## Seattle City Council

### Central Staff – Memorandum

**Date:** April 28, 2016  
**To:** Planning, Land Use and Zoning Committee  
**From:** Ketil Freeman, Council Central Staff  
**Subject:** CB 118655, CF 311936 – Application of Swedish Health Services to prepare a new Major Institution Master Plan for the Swedish Cherry Hill Campus, located at 500 17<sup>th</sup> Avenue (DPD project No. 3012953, Type IV)

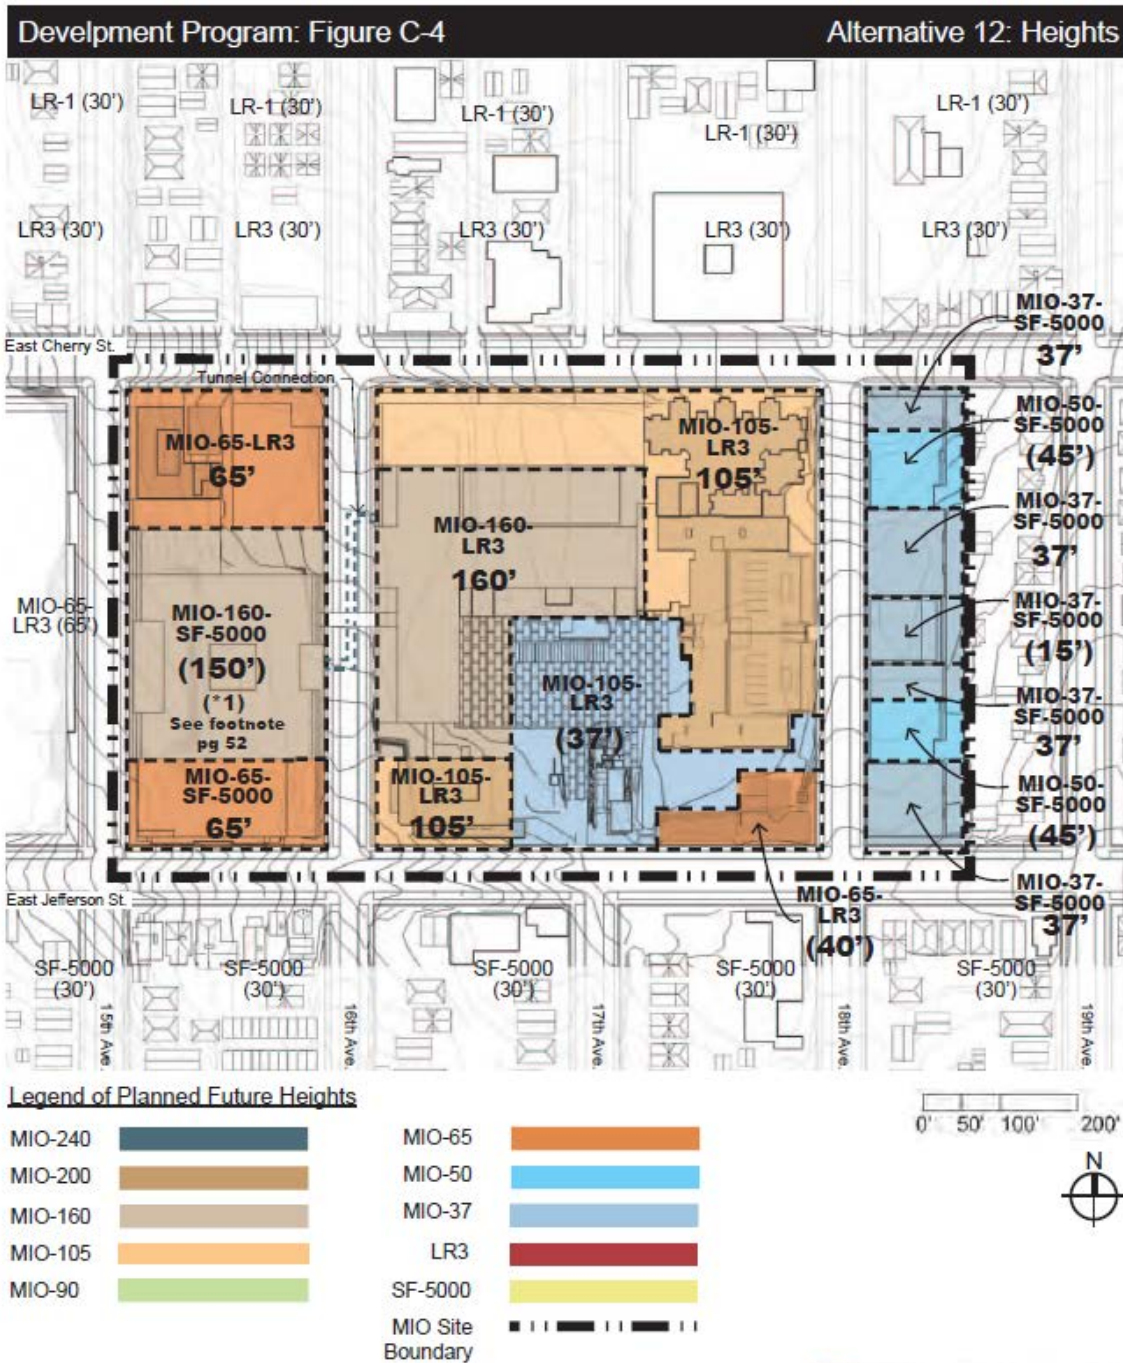
<p><b>2. Height Reduction on the Western Block –</b> Amend CB 118655 and add to and amend the draft Findings, Conclusions and Decision to reduce the proposed MIO height on the western block from 160' (conditioned down to 150') to 105'.</p>	<p><b>CB 118655 – Amend As Shown on Attachment B, Below</b></p> <p><b>Conclusions</b></p> <p style="text-align: center;">***</p> <p>14. Pursuant to the Council’s authority under SMC chapter 23.69, the height, bulk and scale impacts of proposed development on the western block should be reduced by lowering the maximum building height on the western block from the proposed 160 feet to 105 feet.</p> <p style="text-align: center;">***</p> <p>16. As recommended by the Director, the proposed rezone for MIO height districts on the western and central campus (shown in MIMP Figure C-4 on page 53), <del>together with the statement of intent in the footnote on page 52)</del> should be approved subject to the conditions listed below. <u>The proposed rezone for the MIO height district on the western campus should be reduced to 105 feet from the proposed 160 feet (conditioned down to 150 feet). The proposed rezone for two sections of the MIO height district on the east campus (MIO-50) should be denied.</u></p> <p style="text-align: center;">***</p> <p><b>Revisions to Master Plan Text Including Design Guidelines</b></p> <p style="text-align: center;">***</p> <p>53. <b>Western Block Height.</b> <u>Revise all references to MIO height on the block west of 16th Avenue to state an MIO height of 105 feet for the portions of the block proposed to be rezoned to an MIO height of 160 feet (conditioned down to 150 feet).</u></p> <p style="text-align: center;">***</p>
